EPRI New Plant Seismic Program

**Main Comments on Draft Reg. Guide
DG-1146**

December 14, 2006

Example 1E-4 spectra

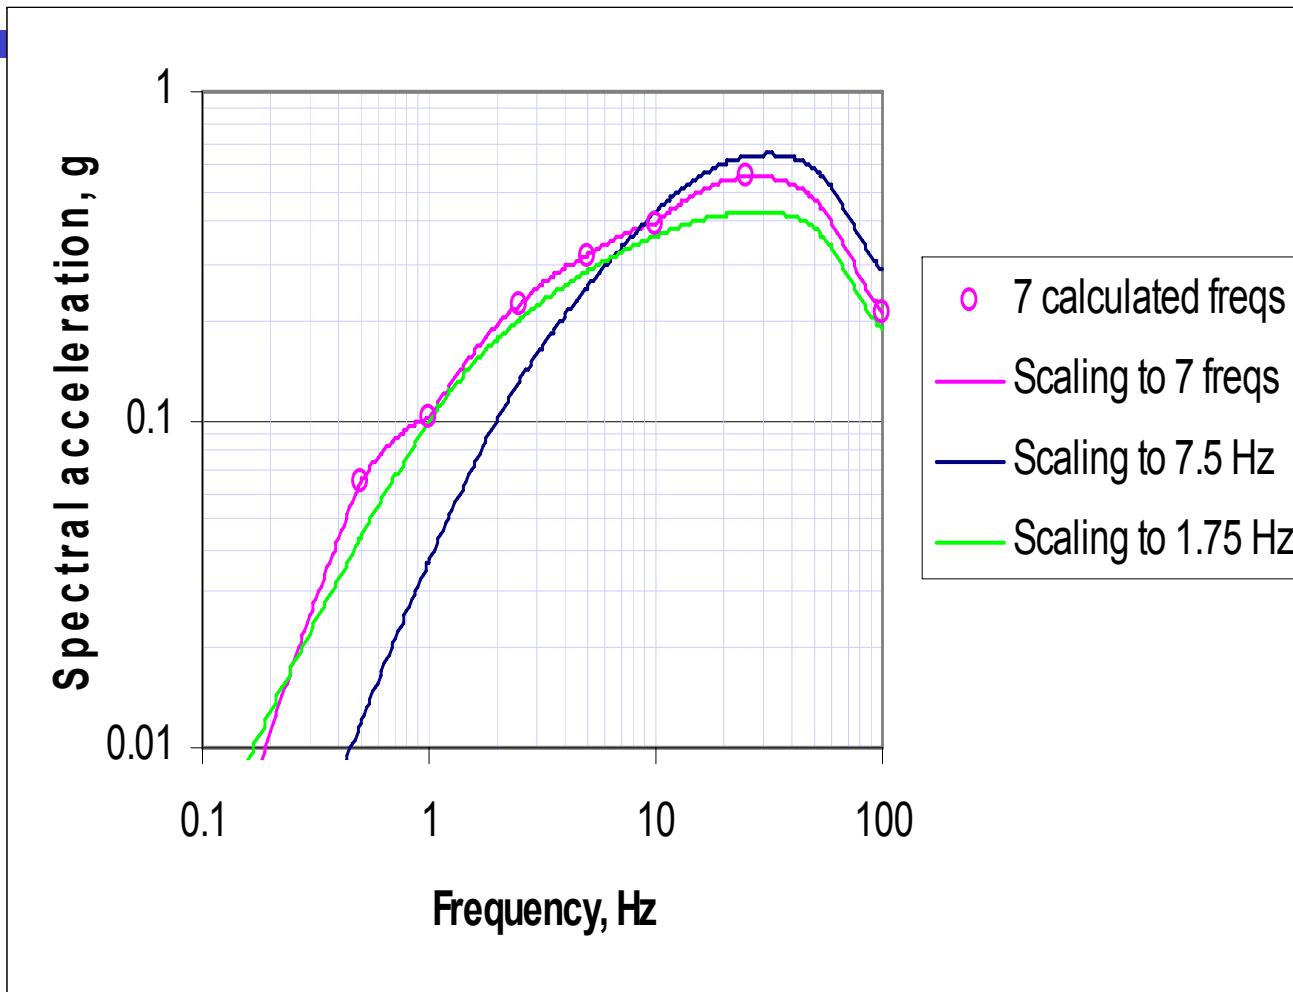
- DG-1146 should clearly state that seismic source characterizations accepted by NRC generically or as part of an ESP or COL application are acceptable starting bases for subsequent site-specific PSHAs.
- Definition of the SSE spectrum needs to ensure that the exceedance frequencies of the UHRS are maintained at the surface over all structural frequencies of interest.
